**Corridor 138-143
Region 3 Review**

Corridor 138-143

Baggs Corridor

Corridor 138-143
Region 4 Review

Figure 3. Map of Conflict Areas in Vicinity of Corridor 138-143

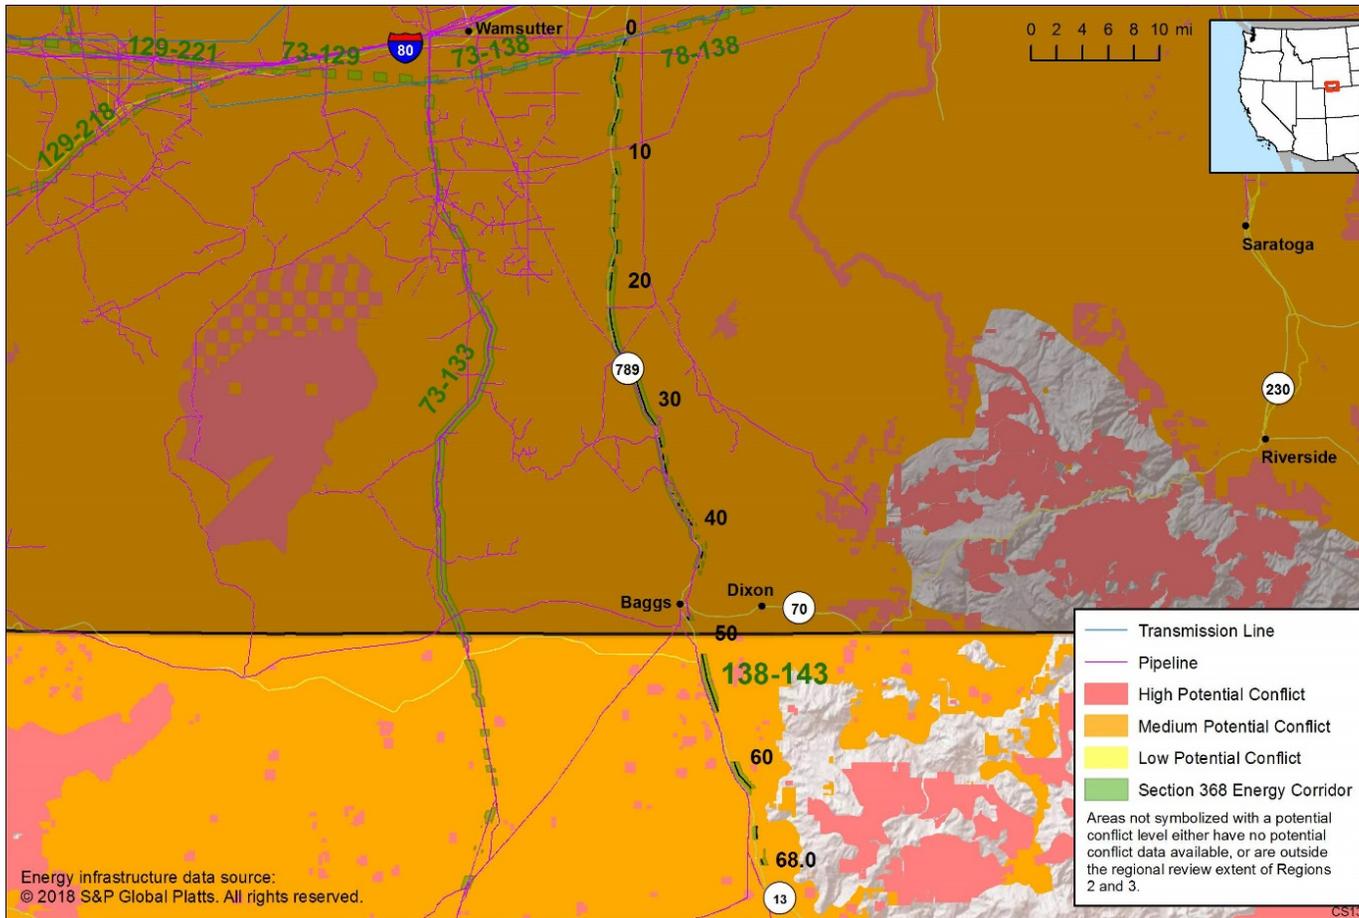
Figure 3 reflects a comprehensive resource conflict assessment developed to enable the Agencies and stakeholders to visualize a corridor’s proximity to environmentally sensitive areas and to evaluate options for routes with lower potential conflict. The potential conflict assessment (low, medium, high) shown in the figure is based on [criteria](#) found on the WVEC Information Center at www.corridoreis.anl.gov. To meet the intent of the Energy Policy Act and the Settlement Agreement siting principles, corridors may be located in areas where there is potentially high resource conflict; however, where feasible, opportunity for corridor revisions should be identified in areas with potentially lower conflict.

Figure 3. Map of Conflict Areas in Vicinity of Corridor 138-143

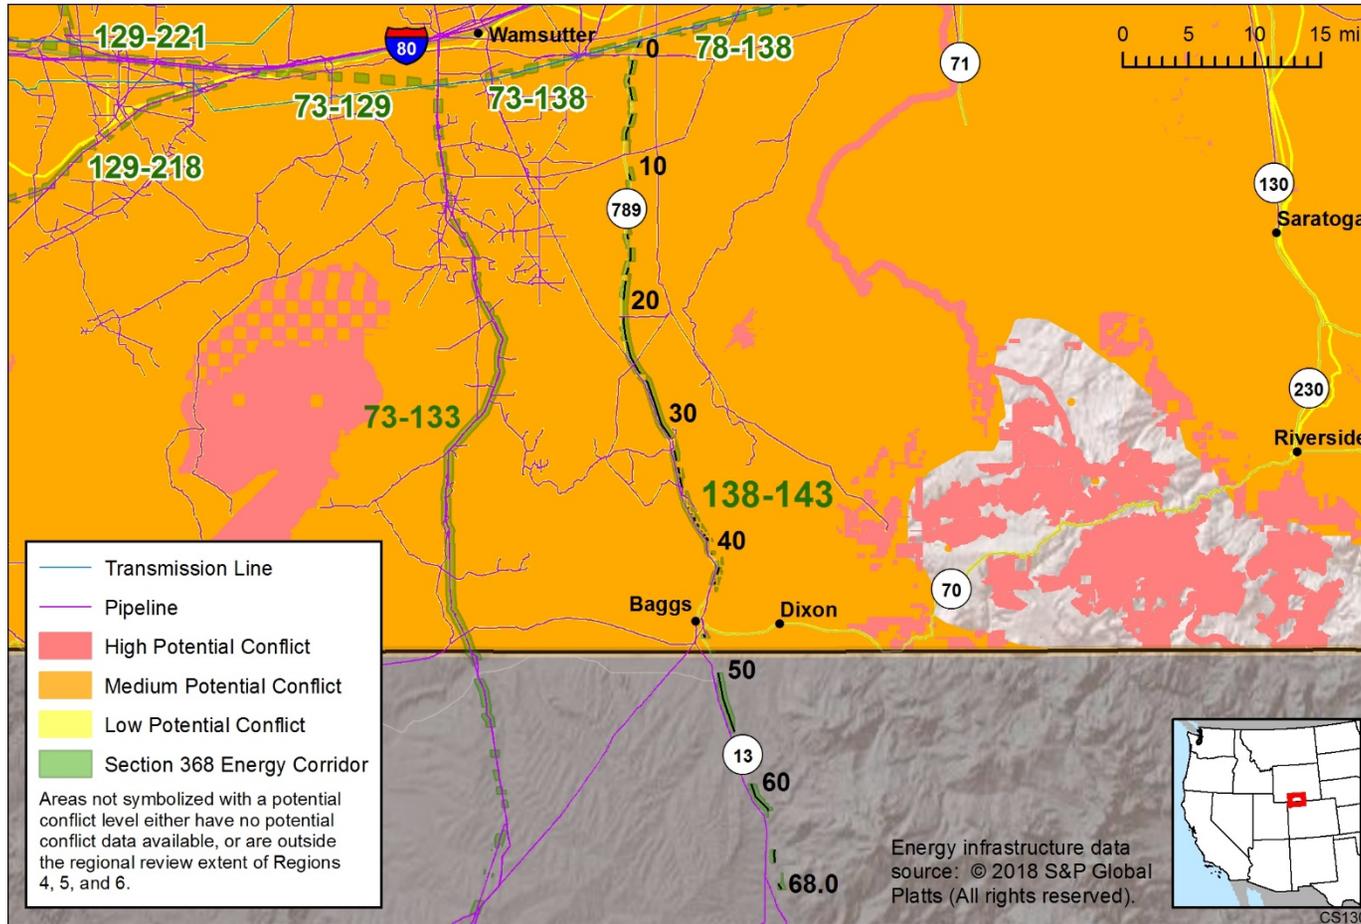
Figure 3 reflects a comprehensive resource conflict assessment developed to enable the Agencies and stakeholders to visualize a corridor’s proximity to environmentally sensitive areas and to evaluate options for routes with lower potential conflict. The potential conflict assessment (low, medium, high) shown in the figure is based on [criteria](#) found on the WVEC Information Center at www.corridoreis.anl.gov. To meet the intent of the Energy Policy Act and the Settlement Agreement siting principles, corridors may be located in areas where there is potentially high resource conflict; however, where feasible, opportunity for corridor revisions should be identified in areas with potentially lower conflict.
